SIB 65 01 22

## KNEE AIR BAG CCM G01 VARIANT WIRE HARNESS REPAIR

This Service Information Bulletin (Revision 5) replaces SI B65 01 22 **dated November 2022**.

## KNEE AIR BAG CHECK CONTROL MESSAGE G01 VARIANTS

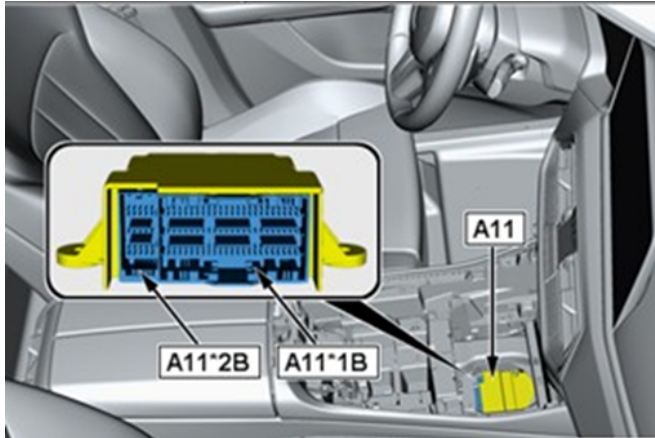
- SIB title changed
- Cause, Correction, and Claim Information sections updated, under-dash panel removal labor ops added, the knee air bags do not need to be removed for this repair.

Over time, the wiring harness going to the knee air bag(s) can rub against the metal support tubes for the instrument panel, chafing and damaging the wiring.

Remove the under-dash trim panels on both the driver's and passenger's sides.

**The knee air bags do not need to be removed.**

The knee air bag harnesses end connectors are cut off and the wiring taped back to the harness.

Run the new air bag repair wiring harnesses from the ACSM control module to both knee air bags.

The replacement harnesses do not need to follow the same exact routing path as the original.

***Both replacement harnesses are to be installed, even if there is only a fault showing for one side.***

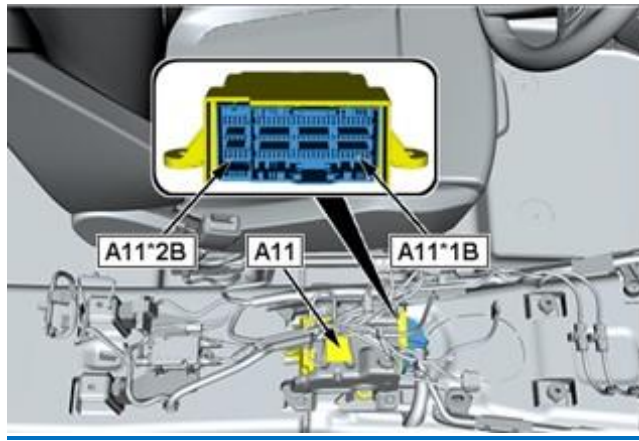
- Correction / Procedure: This repair has been modified to reduce the amount of interior disassembly.

The wiring harness going to the knee air bag(s) may be rubbing against the support tube of the instrument panel.

Remove the knee air bags on **both sides** of the vehicle.

The knee air bag harnesses end connectors are cut off and the wiring taped back to the harness.

Run the new air bag repair wiring harnesses from the ACSM control module to both knee air bags.

The replacement harness does not need to follow the same exact path as the original. **Both harnesses are run regardless of whether there is a fault for one side only.**
